TOWN OF NIVERVILLE

SCHEDULE A
2022 Town of Niverville Construction Standards

March 2022 Revision Summary

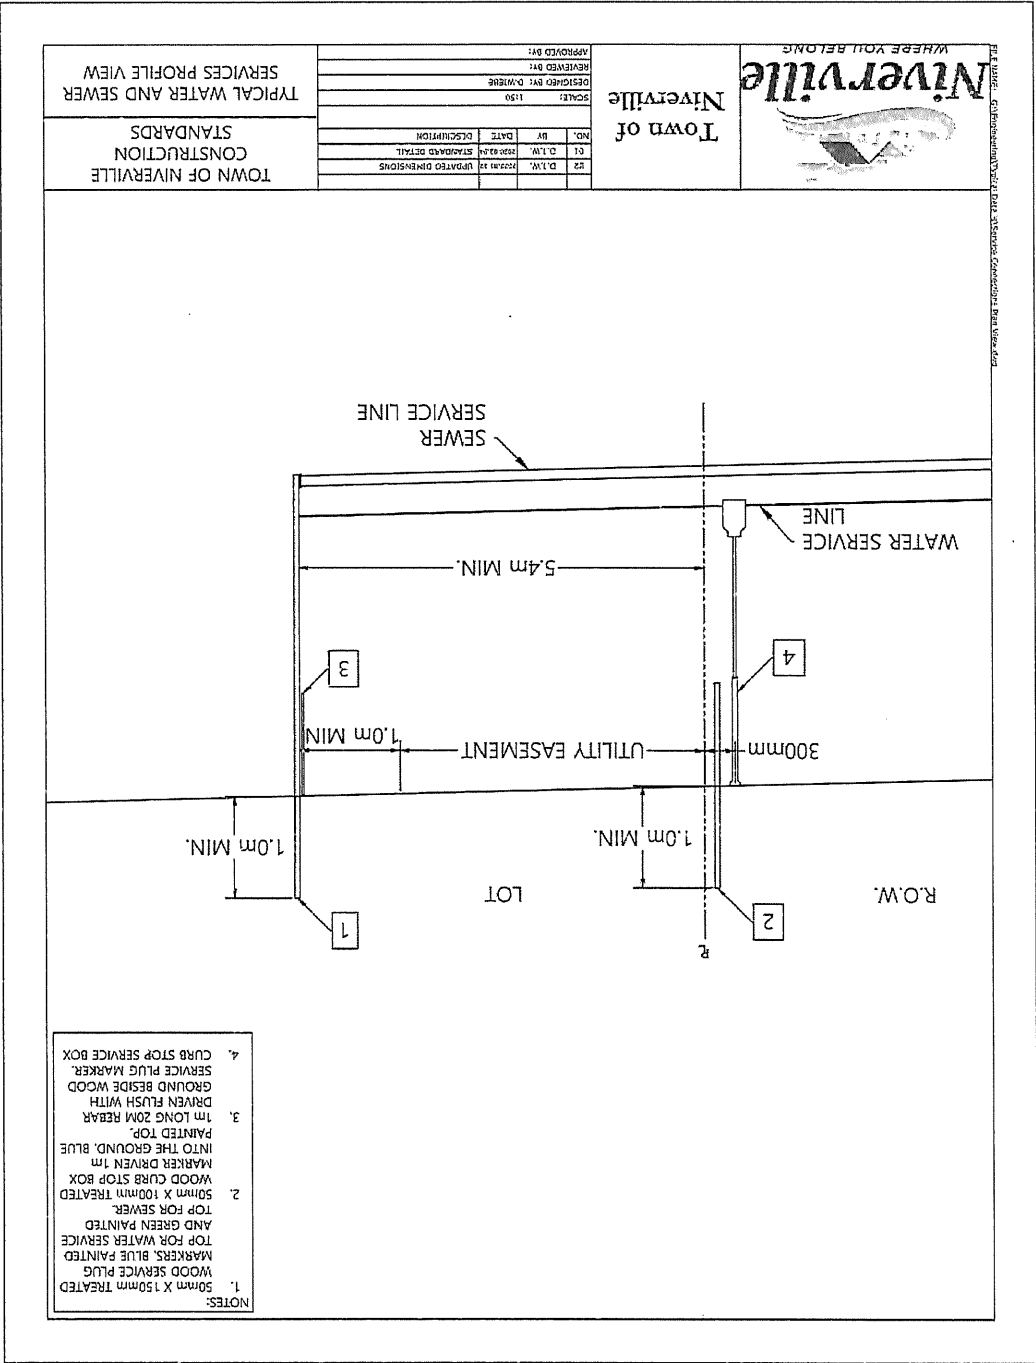
Change: “All water service connection boxes shall be supplied and installed for new subdivision developments. Service lines shall be installed 18 feet (5.4 m) inside the property or 3 feet (1.0 m) outside utility easement, whichever is greater and plugged. The end of each installed service line shall be marked with a 2 inch x 6 inch (50 mm x 150 mm) pressure treated construction grade fir wooden marker with top painted blue. The markers are to be placed at the end of the plugged service and the service is to be backfilled while maintaining the marker plumb. The marker shall extend at least 3 feet (1.0 m) out of the ground. A 3 foot (1.0 m) length of 3/4 inch (20 mm) rebar is to be placed next to the wooden marker, with the top being flush with the ground surface. The curb stop box shall be marked with a 2 inch x 4 inch (50 mm x 100 mm) pressure treated construction grade fir wooden marker driven 3 feet (1.0 m) into the ground and extending at least 3 feet (1.0 m) out of the ground, with the top painted blue. Curb boxes shall be located 12 inch (300 mm) from the front property line. Typical water and sewer services plan and profile view drawings are shown at the end of this section in Drawing G01 and Drawing G02.”

Change: Remove section 2.2(k) since it contradicts section 14.2. Section 2.2(k) referenced MWSB standards, 14.2 references City of Winnipeg standards. Update 14.2 to reference MWSB standards.

Purpose: Match Manitoba Hydro 2x6 requirement, clarify wooden service marker is to mark the exact service end location, and state how far out of the ground the markers must extend.

Purpose: Remove contradiction to clarify standards.

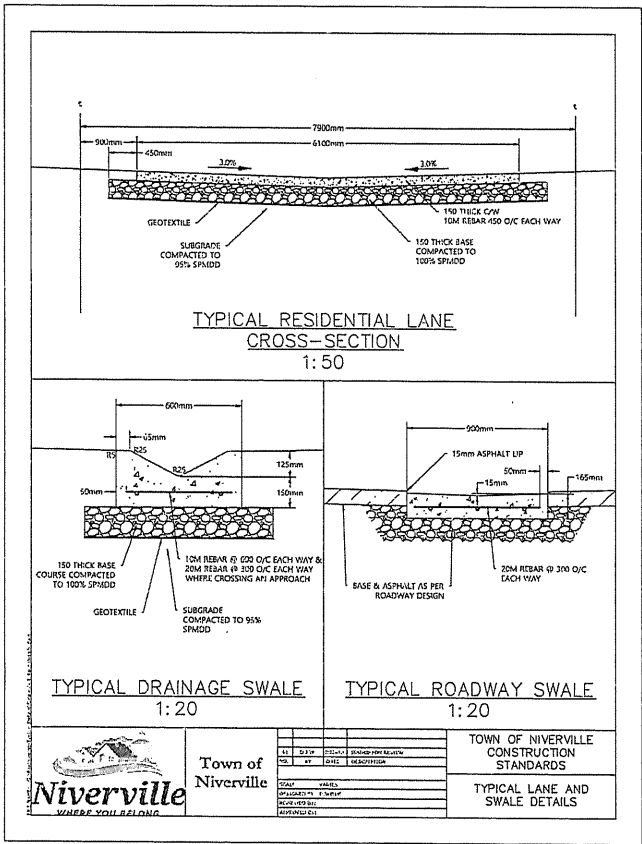
Change: Revised residential lane detail and drainage swale details

Purpose: Match text, show rebar requirements for residential lane and road swales

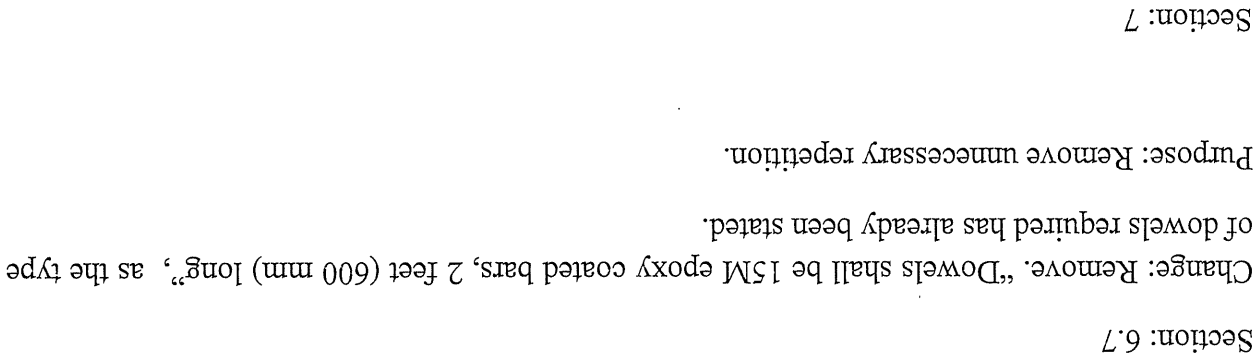
Change: All roadways shall be designed with concrete curb and gutter drainage (with storm sewers as required), unless otherwise permitted in writing by the Town's Designated Officer. Where curbs and gutters are stipulated for residential roadways, a residential roll curb (as per drawing G08) shall be used. See drawing G08 for alternative curbing cross-sections that may be approved for specific areas by the CAO or Designated Officer in writing. The curb and gutter shall be slip formed concrete, with the gutter being a minimum of 6 inches thick (150 mm). Two (three for barrier or modified barrier curbs) epoxy dowels shall be used to tie into new curbing at curb repairs or construction joints.

that includes all standard curb types.

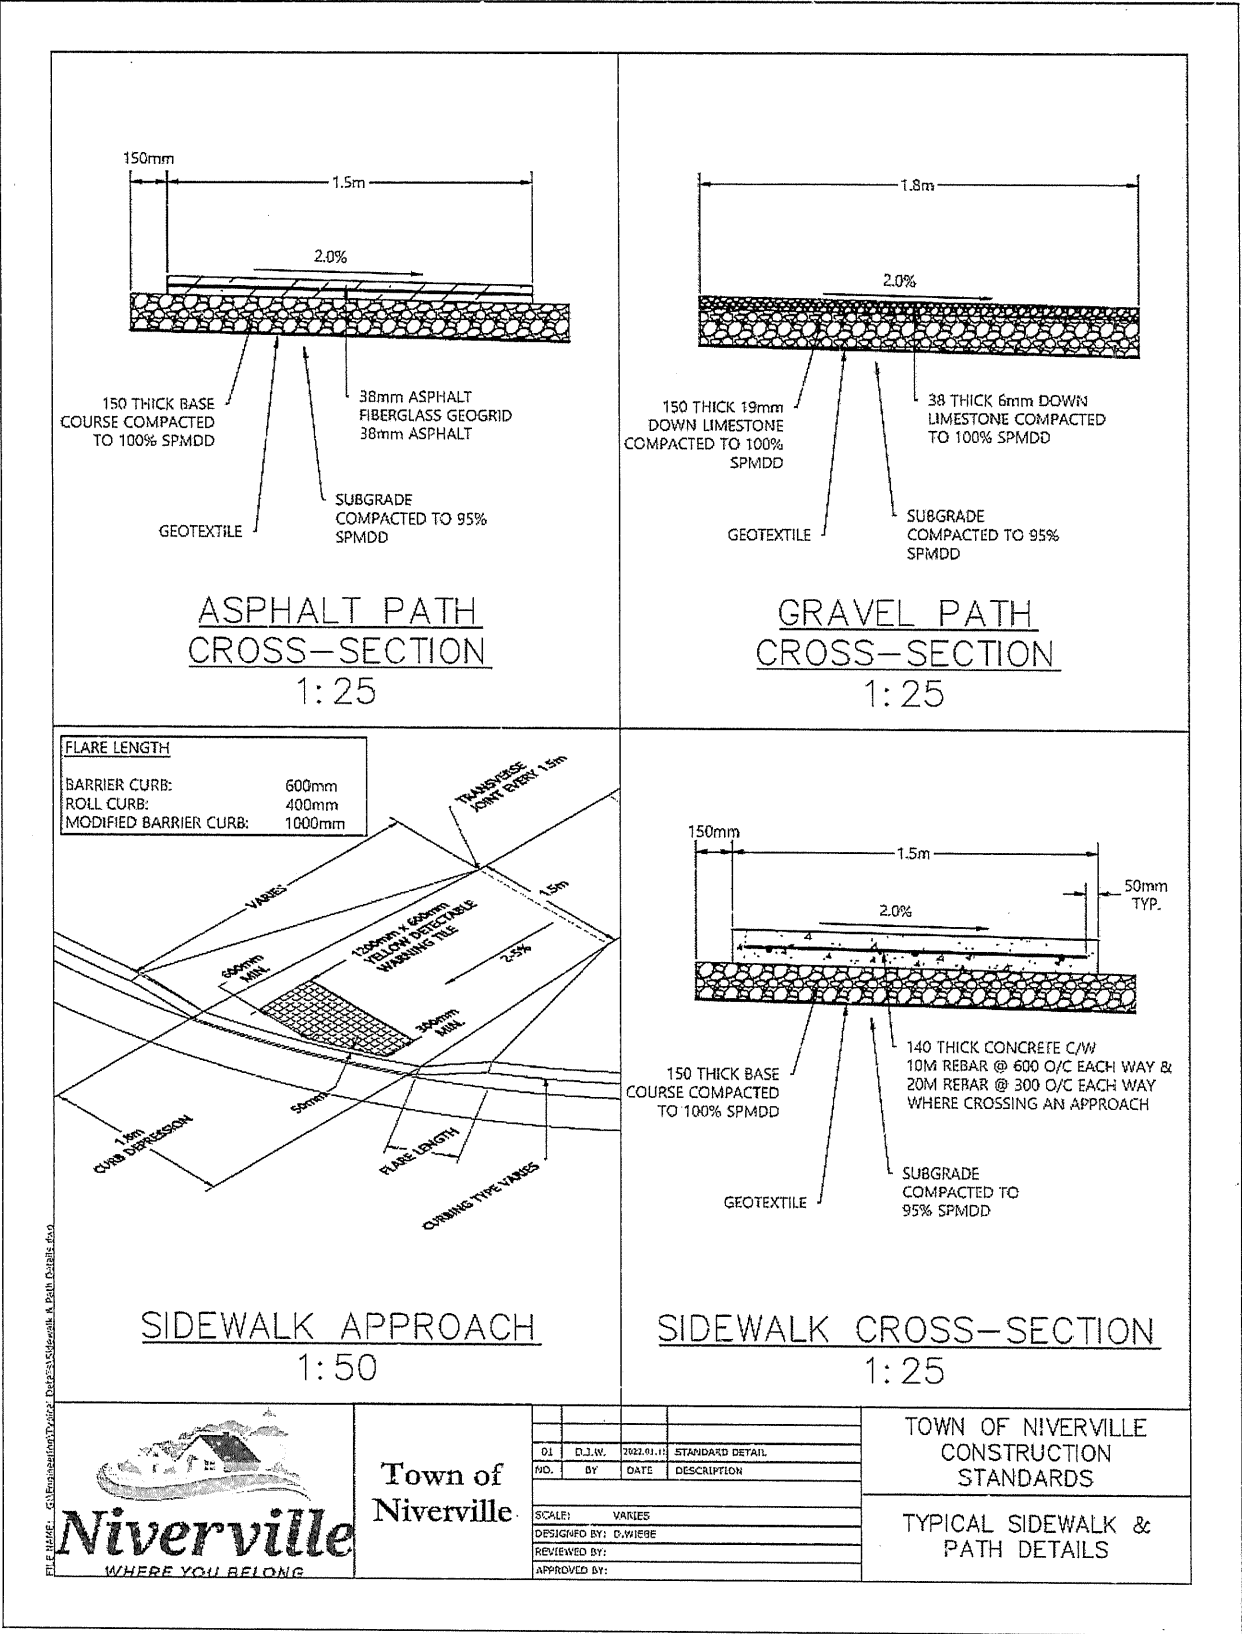
(150 mm) thick and extend 6 inches (150 mm) wider than the finished sidewalk. Concrete shall be no less than 5.5 inches (140 mm) thick. Rebar must be used; 10M, 2 feet on center (600 mm) or if crossing an approach: 20M, 1.0 foot (300 mm) on center,” and Removed “When approved by Council, walking paths installed in Public Reserves shall consist of: 3 inches (75 mm) of asphalt over 6 inches (150 mm) of limestone base material. Base shall be 6 inches (150 mm) wider than the finished surface. For all sidewalks installed in Public Reserves, a separation / reinforcement geotextile fabric shall be placed below base materials and shall be a woven fabric. Geotextile fabric shall be as specified in Section 6.5.” since all those details are on the new drawing detail. Added “Asphalt mix for asphalt paths shall have an aggregate size that allows for 1.5 inch (38mm) lifts of asphalt between the fiberglass geogrid.”

Purpose: Drawings provided and text removed to better clarify and visual our requirements. 2% is enough slope for drainage but more than 2% isn’t good for accessibility reasons. Compacted ¼” down limestone added to meet accessibility requirements. Fiberglass geogrid added to reduce cracking and increase longevity of asphalt paths.
